## System Restoration Strategy Senior Task Force (SRSTF) Manual Updates

4/24/22/13

The following Manuals were reviewed and updated as necessary based on the SRSTF recommendations.

Figure X – Example of level one cross zonal coordination. In this example Black Start units one and two both supply TO Zone A even though Black Start Unit two is located in TO Zone B.

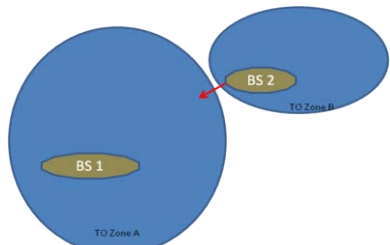
Restoration plans would remain on a TO basis, but coordinated between TOs. The cross-zonal coordination must be documented in both the receiving TO restoration plan and the supplying TO restoration plan. The supplying TO would document the cranking path from the Black Start unit to an agreed upon border with the receiving TO. The receiving TO would document the cranking path from the agreed upon border with the supplying TO to the critical load that is being supplied.

Black Start redundancy will be evaluated on a TO zonal basis (2 BS units allocated to each TO zone, though physically may be outside zone)

Figure X – Example of level two cross zonal coordination. In this example Black Start unit two is shared between TO Zone A and TO Zone B. Critical load is restored from this unit

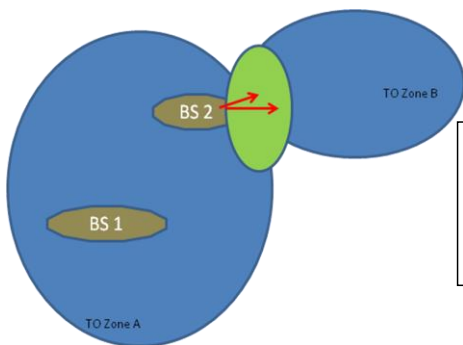
Restoration plans would be on a TO basis, but coordinated between TOs. The Level two cross zonal coordination must be documented in both TO Restoration Plans. Redundancy would be on a TO basis (2 BS units allocated to each zone, though physically may be outside zone)

### 9.1.3 Level Three Cross Zonal Coordination

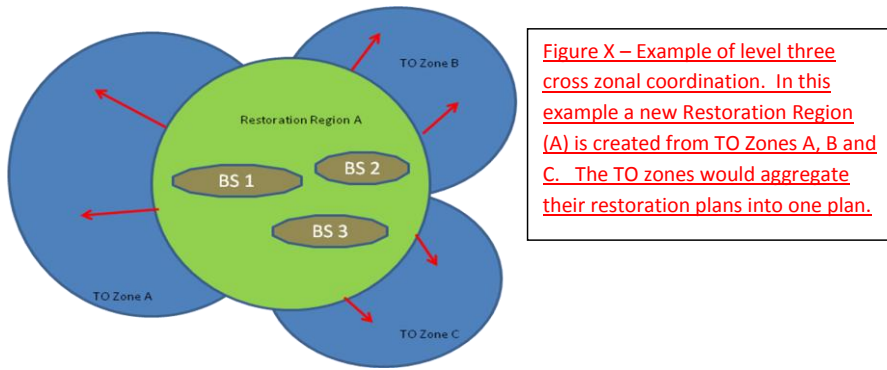
Level three cross zonal coordination refers to fully aggregate TO restoration plans into a combined plan for a newly defined Restoration region. This could be done to eliminate a Black Start shortage in a zone (reliability requirement), meet critical load restoration timing requirements (reliability requirement), improve restoration speed or efficiency (efficiency opportunity) or significantly reduce Black Start cost (efficiency opportunity).

Level three cross zonal coordination would involve merging of 2 or more existing TO zones or creating new Restoration Regions (new boundaries). There would be one Restoration plan for the aggregated area(s). Redundancy requirements would be evaluated on a Restoration region basis.
